DELEGATED DECISION REPORT

SMD/2025/0509
Valid 05/12/2025

LYTCHGATE COTTAGE
CHURCH BANK
CAULDON

**LISTED BUILDING CONSENT
FOR REPLACEMENT
WINDOWS AND FRONT DOOR,
TO REPLACE FRONT PORCH
BY AN UNENCLOSED TILED
DOOR CANOPY, TO REPLACE
RAINWATER GOODS AND
EXTERNAL
LIGHTING AND TO REMOVE
TV ANTENNA**

Rear Elevation

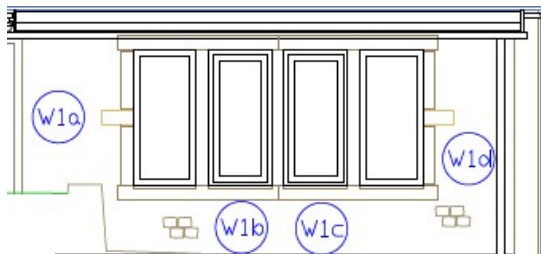
Replace ground floor window with top opener with double glazed hardwood, side hung, half casement windows, with one side fixed and the other side opening, subdivided by narrow glazing bars, painted cream. (Rear).

Consent sought retrospectively for window installations made in 2023 to rear of flat roof extension.

Front Elevation (Ground floor front)

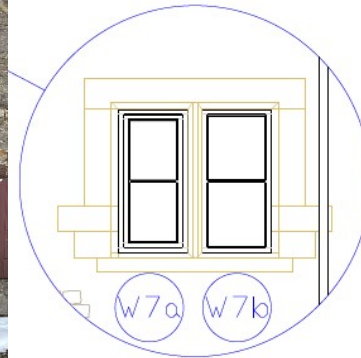
Replace both ground floor windows with window panels between chamfered stone mullions and remove faux shutters.

W5a, W5b are identical

Revised windows details to include: True glazing bars (not painted), slim-line glazing units, glazing fixed with external putty bead (not timber beading).

D2

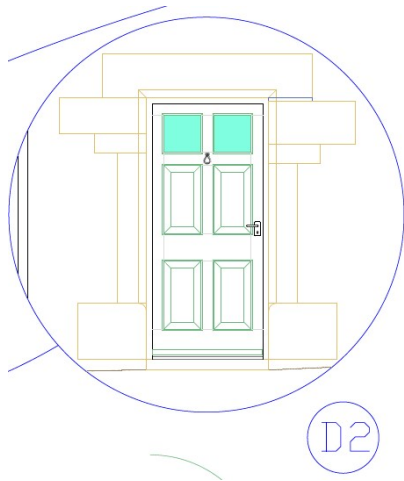
Remove cotoneaster and pergola surround, and the carriage lanterns. Replace the front door with detail at D2 (panelled door painted sage green). Install new tiled canopy over new front door (** subject to revision detailed below). Install new black cast metal rainwater goods. Install low power eyelid lights to porch support brackets (** subject to revision detailed below).

However, there are a few details which may result in minor-moderate degree of harm to the Listed Building including the double-glazing thickness, replacement external lighting and canopy detailing.

- Replacement windows to be slimline double glazing with integral glazing bars
- Alterations to the design of the porch/canopy to the front elevation

Proposed porch detail substituted with moulded stone hood
Eye lid lights to be mounted to side of door.

I originally proposed a simple tiled door canopy because I felt it would be more legible as a later addition than a stone hood moulding and therefore better conservation practice. However, I accept that a tiled canopy would lend a Victorian appearance to a Georgian era building and a stone hood moulding would be more in keeping. The Rev 1 plans show a gritstone hood moulding supported by moulded gritstone corbels. There are several examples in the village of Cauldon including Old Vicarage Farm, the former Coach and Horses, and more widely in the Staffs Moorlands.
